[Federal Register Volume 76, Number 55 (Tuesday, March 22, 2011)]  
[Rules and Regulations]  
[Pages 15808-15814]  
From the Federal Register Online via the Government Printing Office [www.gpo.gov]  
[FR Doc No: 2011-5301]

**[Docket No. FAA-2009-1253; Directorate Identifier 2009-NM-080-AD; Amendment 39-16629; AD 2011-06-05]**

### **Airworthiness Directives; The Boeing Company Model 737-600, -700, -700C, -800, -900, and -900ER Series Airplanes**

**ACTION:** Final rule.

**Figure 1**

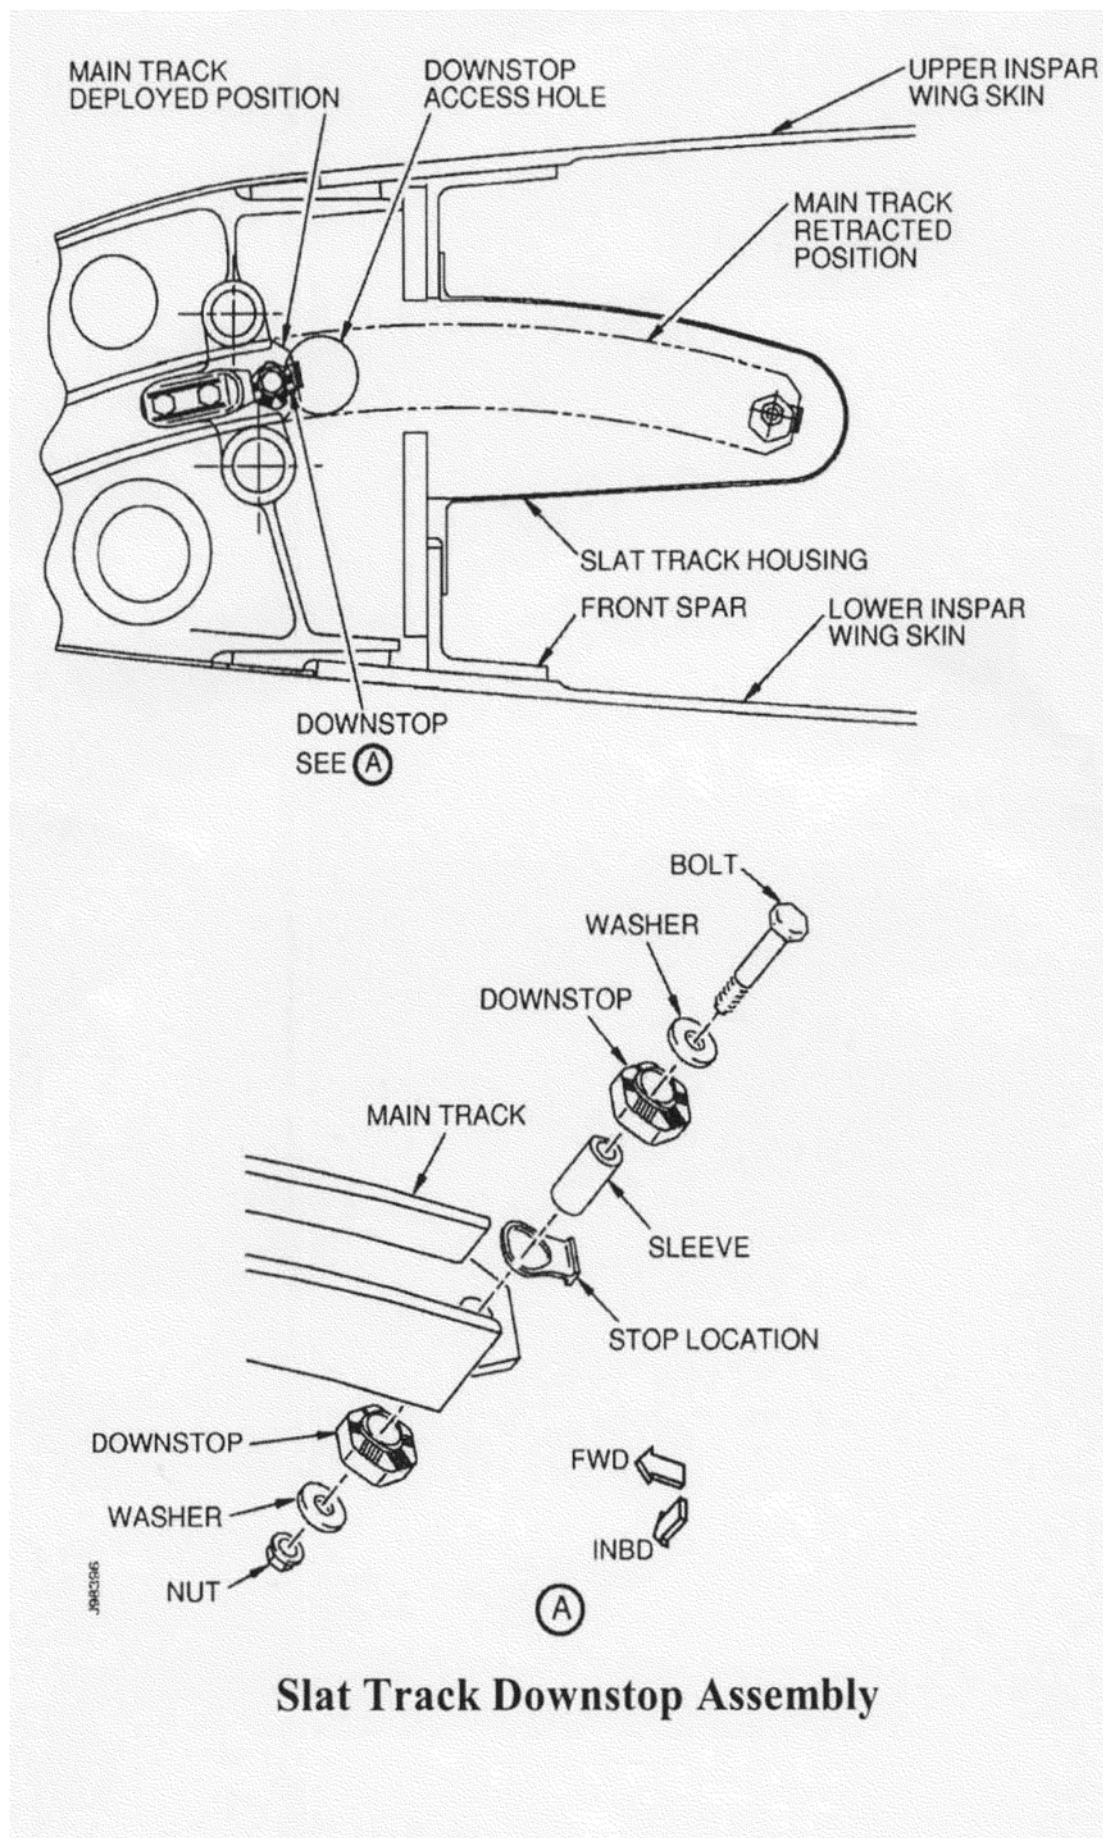
- (g) Within 10 days after September 26, 2007 (the effective date of AD 2007-18-52): Do a detailed inspection or a borescope inspection of each main slat track downstop assembly to verify

proper installation of the slat track hardware (i.e., the bolt, washers, downstops, stop location, and nut shown in Figure 1 of Boeing Service Letter 737-SL-57-084-B, dated July 10, 2007, and in this AD). Proper installation of the sleeve need not be confirmed, and the stop location part may be installed on either the inboard or the outboard side of the slat track. If any part is missing or is installed improperly, before further flight, install a new or serviceable part using a method approved in accordance with the procedures specified in paragraph (j) of this AD; and do a detailed inspection of the inside of the slat can for foreign object debris (FOD) and damage. Before further flight, remove any FOD found and repair any damage found using a method approved in accordance with the procedures specified in paragraph (j) of this AD. Verify proper installation; install a new or serviceable part; and inspect for damage and FOD, and remove FOD and repair damage; in accordance with a method by approved by the Manager, Seattle Aircraft Certification Office, FAA; or in accordance with Boeing Multi Operator Message Number 1-523812011-1, issued August 25, 2007, or 1-527463441-1, issued August 28, 2007. Repeat the actions required by paragraph (g) of this AD thereafter at intervals not to exceed 3,000 flight cycles.

(h) Within 24 days after receipt of emergency AD 2007-18-51: Apply a torque between 50 to 80 inch-pounds to the nut. The bolt head must be held with the torque applied to the nut.
